CERTIFICATE OF APPROPRIATENESS APPLICATION FORM

Address 501 Highland Street
 Historic District / Landmark Woodland Heights HCAD # 0372 840000 16
 Subdivision Woodland Heights Lot 16 Block 19

Subject: COA Application – 501 Highland Description

This project obtained an initial COA on April 1, 2015 and a revised COA on October 22, 2015. We would like to propose the following revisions to the project.

PROPOSED FIRST FLOOR

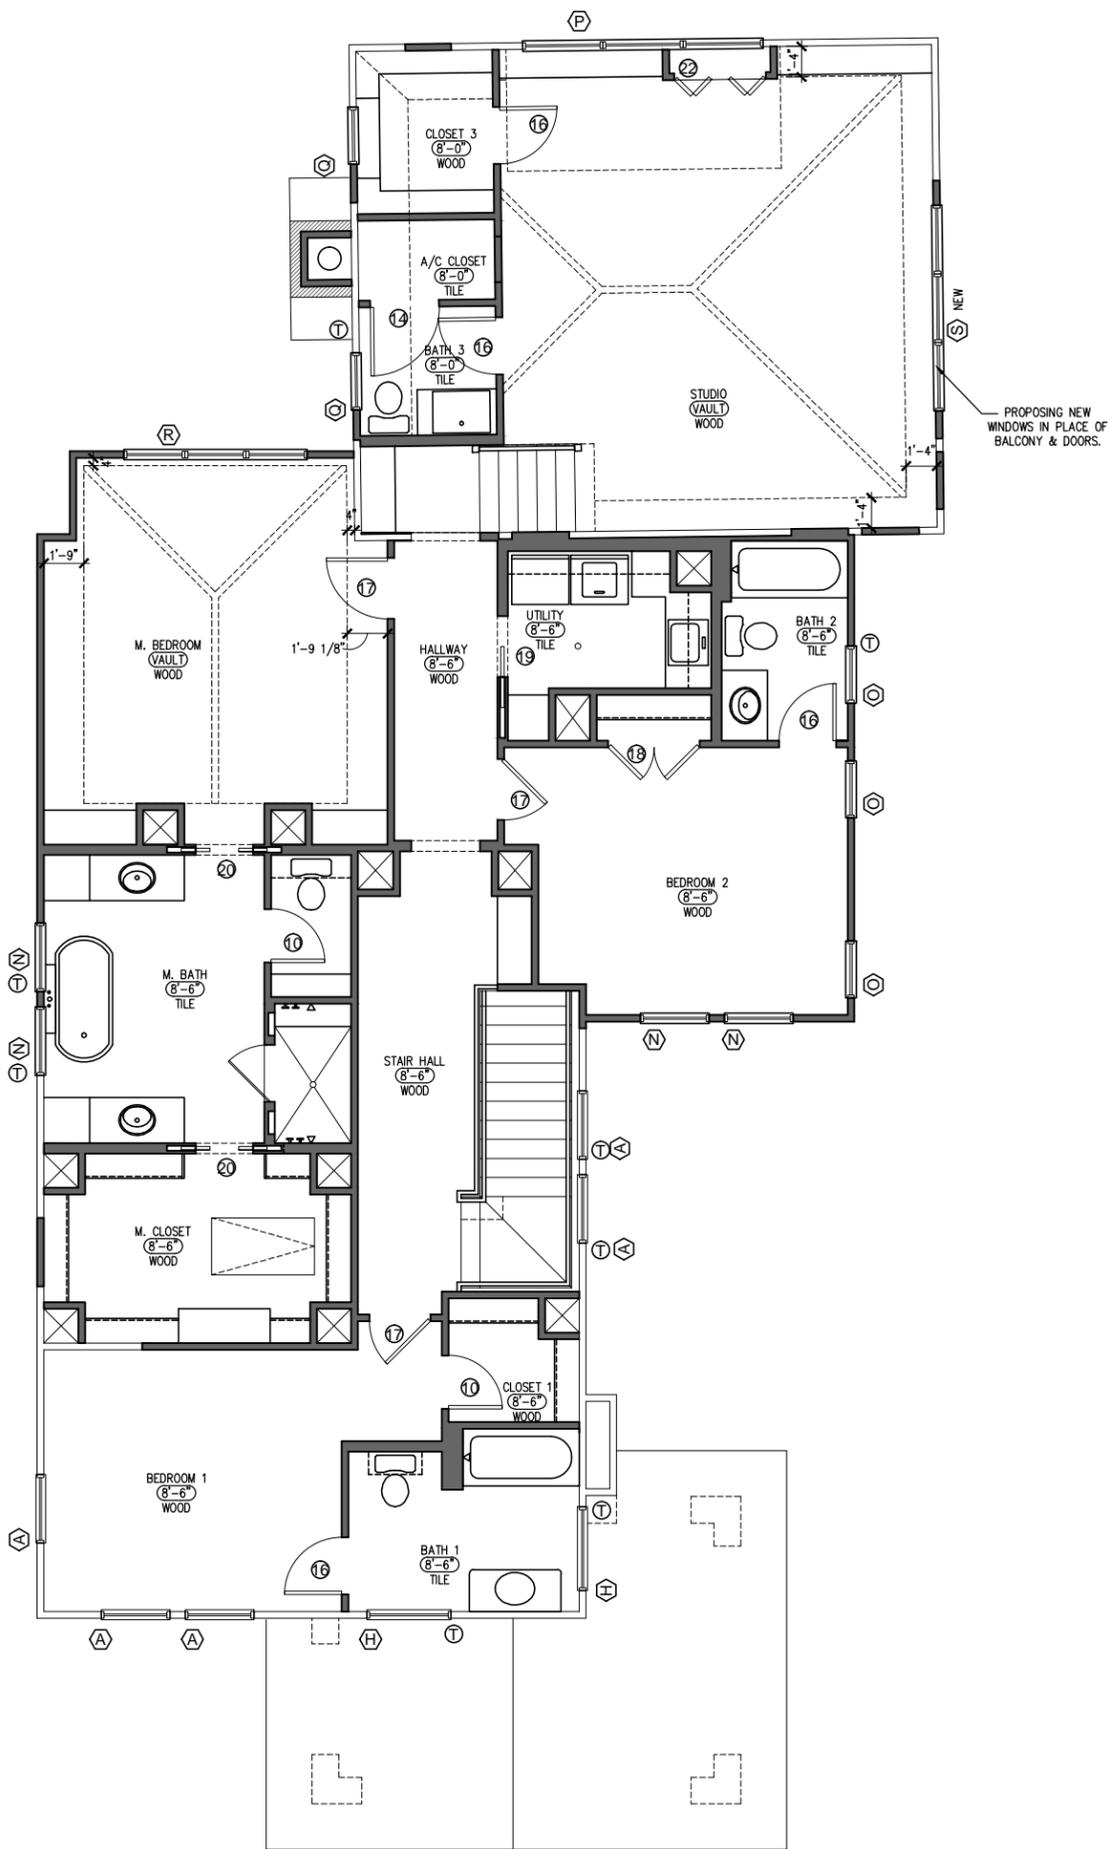
In the initial COA application, a second set of stairs from the front porch was approved to be constructed. We propose that those steps not be constructed and be returned to the original porch design. There was also a set of stairs coming from the family room down into the back patio. We would also like to propose that those steps not be constructed.

We would like to propose that the set of new stairs coming from the kitchen, and the correlating roof overhang, be extended an additional 3'-1 1/2" towards the existing house. This will center the porch and roof overhang on the existing second floor windows. We would also like to propose that the roof overhang be a metal roof instead of an asphalt shingle roof.

PROPOSED ROOF PLAN
SCALE: 1/8" = 1'-0"

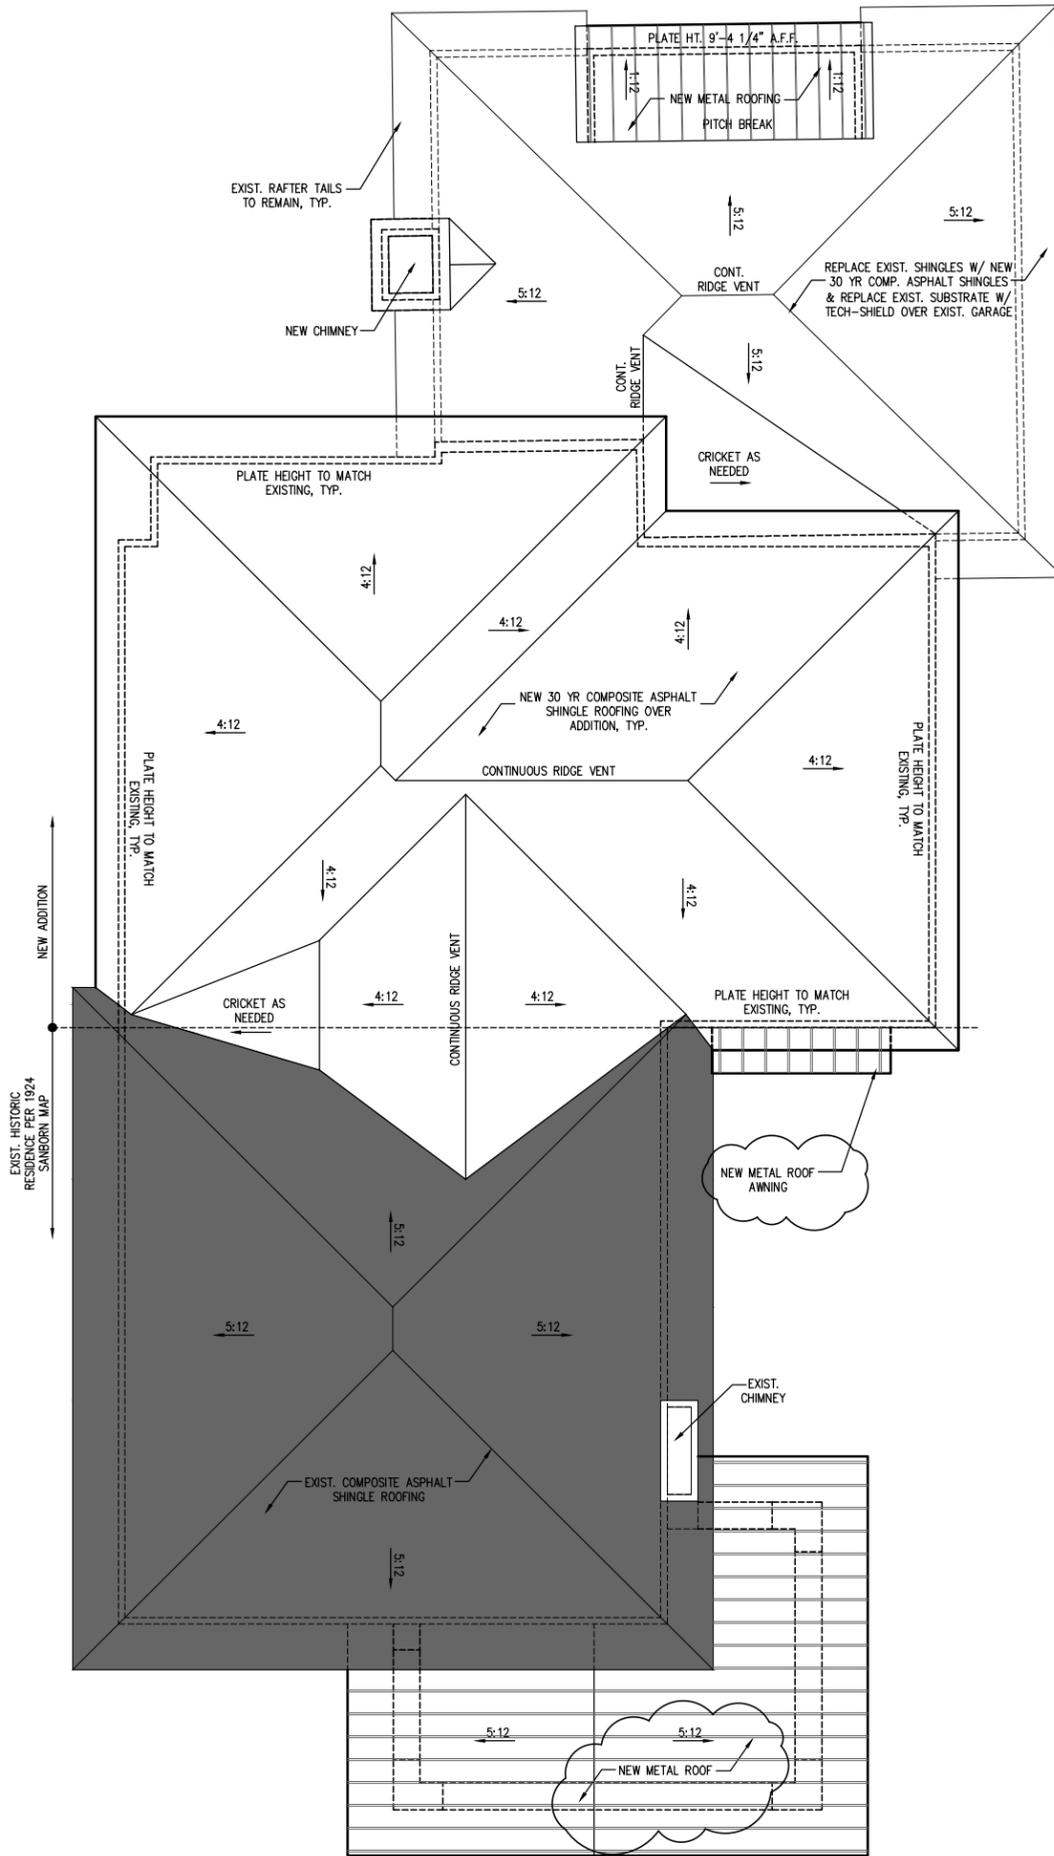
The revised COA on October 22, 2015 allowed the reconstruction of a new front porch to match the existing porch that had been removed. We would like to propose that the new roof on the front porch be a metal roof instead of an asphalt shingle roof.

PROPOSED ELEVATIONS
SCALE: 1/8" = 1'-0"

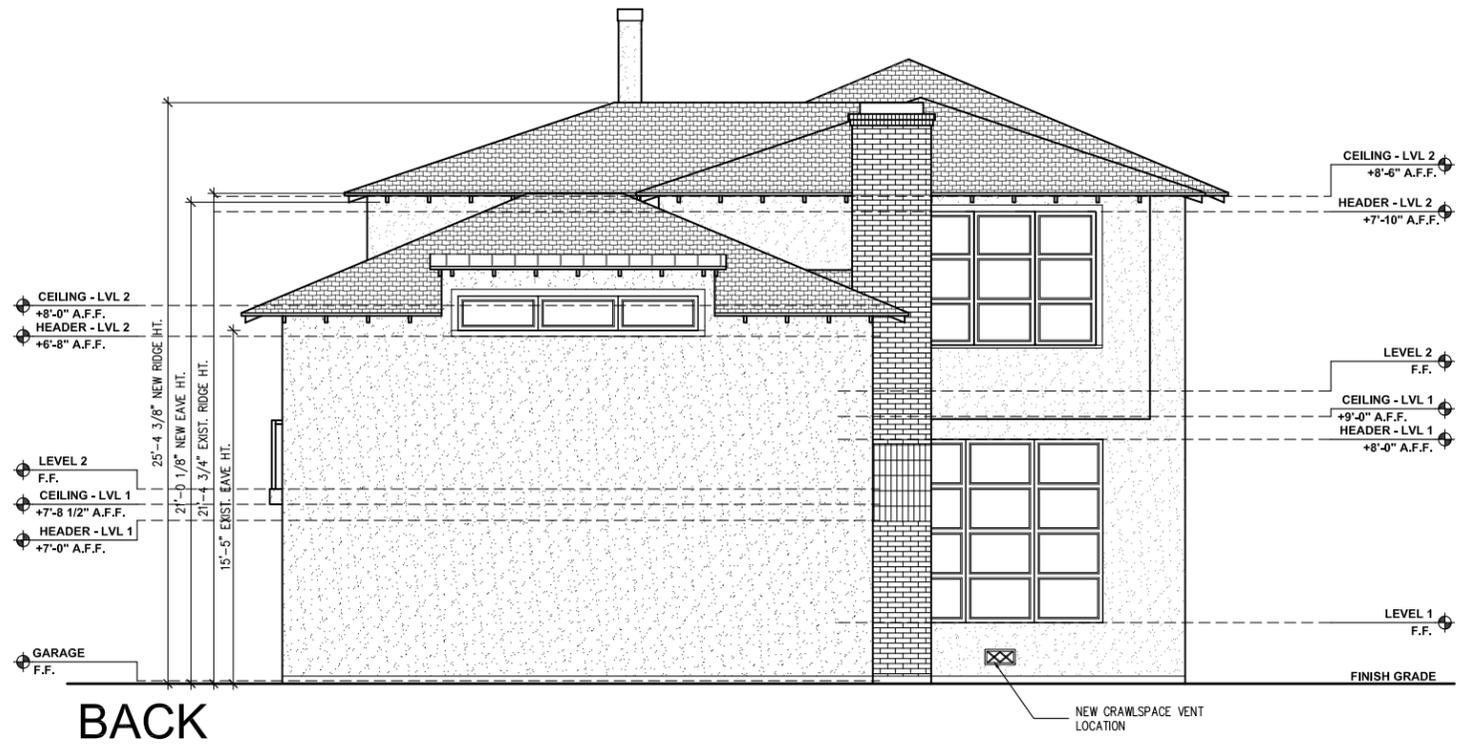
The initial application also included a small balcony, set of doors, and two windows on the second floor of the garage facing Helen Street. We would like to revise those items to only be three aluminum clad windows. The two outer windows will be operable casement windows and the middle will be one fixed window.
